# Bethesda Downtown Design Advisory Panel

**7000 Wisconsin Avenue  
Site Plan Supplemental Narrative  
January 22, 2020 Design Advisory Panel Meeting**

**7000 Wisconsin Ave  
Bethesda, MD**

**Design Advisory Panel  
Pre-Submission  
Preliminary Plan and  
Site Plan**

Massing Comparison

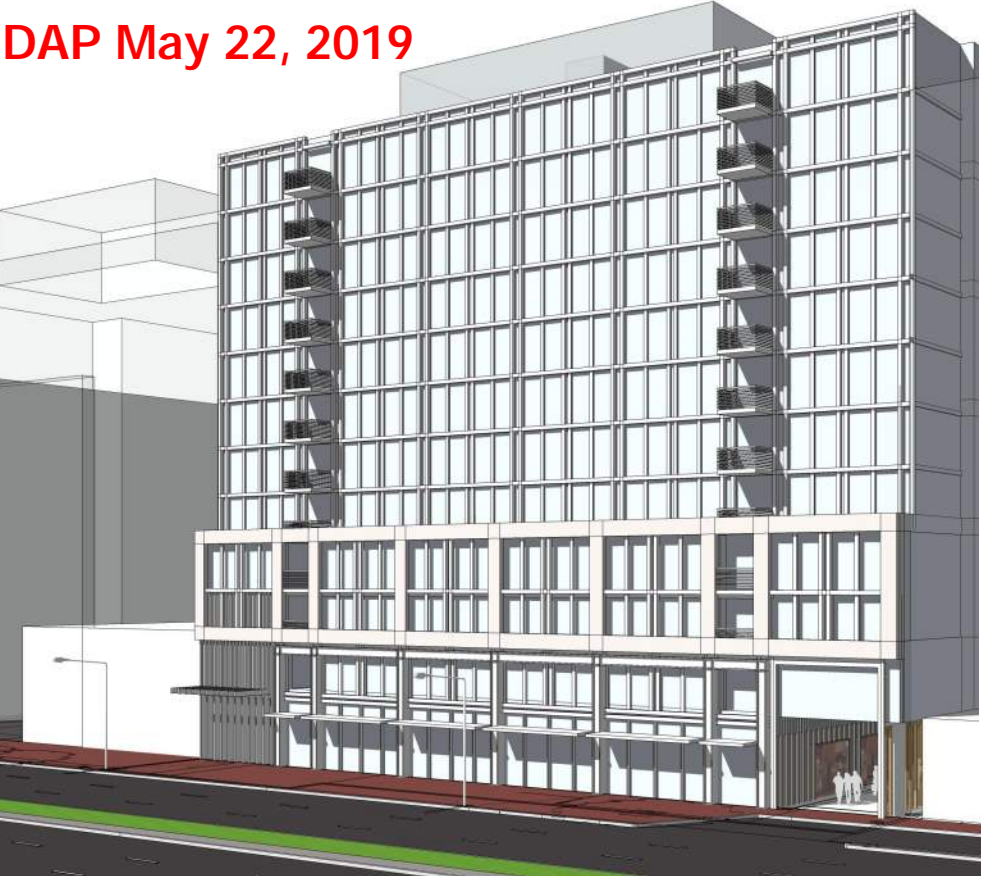
- Discussion Points:
- The Applicant should submit revised drawings to be discussed at the January DAP meeting addressing the points included in this memorandum.

- The panel accepts the shown 45' base and 6' step-back, but in conjunction with efforts to address the tower separation comments below.
  - Members of the panel are concerned that the current design does not sufficiently address tower separation above the base on Wisconsin Avenue, and will contribute to a monolithic building façade as the block redevelops. Given that the building is under 120' tall and on a constrained site, meeting the spirit, rather than the specific criteria, of the tower separation may be appropriate on this site.

- The Applicant should explore the following alternatives:
- Tower separation above the base on the south side could be a minimum of 15' deep;
  - The composition of the north side of the project could be pushed forward to account for the additional setback on the south side.

- Explore alternative treatments of the base element to accentuate the tower separation efforts above (e.g., flipping it about the vertical axis) and the mid-block connection

- Panel Recommendations:
1. The Applicant should submit revised drawings to be discussed at the January DAP meeting addressing the points included in this memorandum. The project will be revised and reviewed again at the Panel's January meeting.

Response to DAP comments

1. 45' base and 6' set-back
- 2a. tower separation above the base on Wisconsin Ave. to reduce monolithic building facade
- 2b. set-back on the North side(minimum 15' deep)
3. alternate treatments of the base to accentuate the tower separation efforts
